SNOW ROAD SUBDIVISION

APPLICATION NUMBER 5 DATE February 7, 2013
APPLICANT Snow Road Subdivision
REQUEST Subdivision

DETAIL SITE PLAN

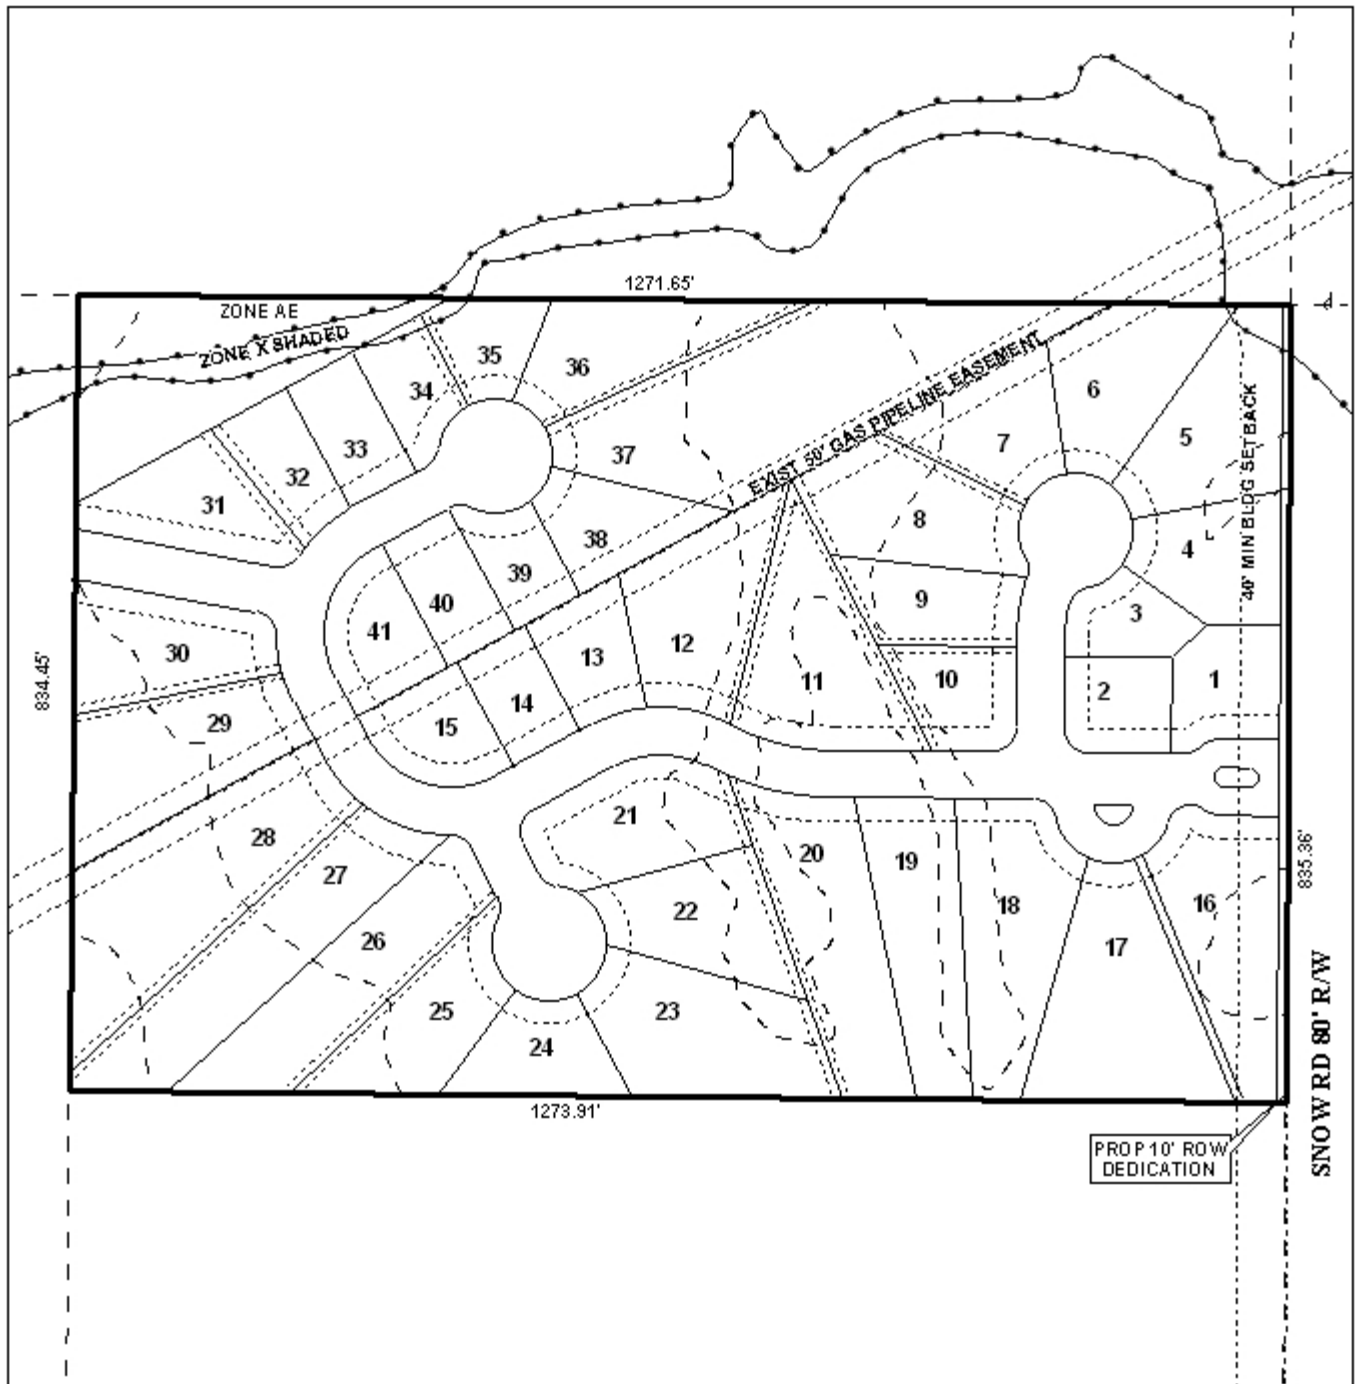
It should be noted that the site abuts a land-locked parcel to the West. Section V.B.1. of the Subdivision Regulations require the provision of street-stubs to adjacent properties, therefore the plat should be revised to depict the provision of one street-stub to the land-locked property to the West.

All lots appear to meet minimum size requirements for properties served by public water and sewer systems. Additionally, the 25-foot minimum building setback line is depicted on the preliminary plat, however, the plat should be revised to additionally depict it along the rear of Lot 43, where it is within 25-feet of Street "B."

An existing 50-foot wide waterline easement along Snow Road creates a minimum 40-foot building setback for those lots with rear frontage onto Snow Road. A second easement, a 50-foot wide gas line easement, cuts diagonally across the site, which is accommodated along rear or side lot lines. A detention common area is depicted on the plat, but no drainage easements are depicted to the common area: the plat should be revised to depict an access easement to the proposed detention facility, and any other drainage or utility easements which may be required as part of the development. A note should be placed on the plat stating that no permanent structures may be placed in any easement.

The proposed detention area includes Zone AE and X-shaded flood zones. The applicant should ensure that the location of any detention facility complies with Mobile County Engineering requirements.

- 1) Provision of a street-stub to the property abutting the site to the West;
- 2) Provision of a 25-foot setback along the rear portion of Lot 43;
- 3) Provision of an easement to the proposed detention facility from a public street, and depiction of any other drainage or utility easements which are anticipated for the development; and
- 4) Revision of lot size and other plat information based upon the provision of the requested street stub.

A revised plat was submitted, depicting the requested street stub to the land-locked property to the West, the provision of various drainage and utility easements necessary for the subdivision, and a revised lot layout. The proposed number of lots has been reduced from 65 lots to 41 lots.

The revised plat depicts wetlands and floodplains. All lots appear to meet minimum lot size requirements, and those lots with wetlands or floodplains are larger in size, to provide buildable area outside of any designated wetlands or floodplains.

As revised, the Subdivision request is recommended for Tentative Approval, subject to the following conditions:

- 1) dedication of 10-feet of right-of-way along Snow Road, as proposed;*
- 2) provision of the street stub to the west, as proposed;*
- 3) labeling of all commons areas, and the placement of a note on the final plat stating that the maintenance of the common areas is the responsibility of the property owners;*

- 4) construction and paving in asphalt or concrete of the roads in compliance with Mobile County Engineering requirements, and acceptance thereof, prior to the signing of the final plat;*

- 5) placement of a note on the final plat stating that no permanent structures may be placed in any easement;*
- 6) placement of a note on the final plat stating that any lots which are developed commercially and adjoin residentially developed property must provide a buffer, in compliance with Section V.A.8. of the Subdivision Regulations;*

- 7) placement of a note on the final plat stating that all lots are denied direct access to Snow Road, and are limited to one curb-cut each, with the size, design and location to be approved by Mobile County Engineering and to comply with AASHTO standards;*
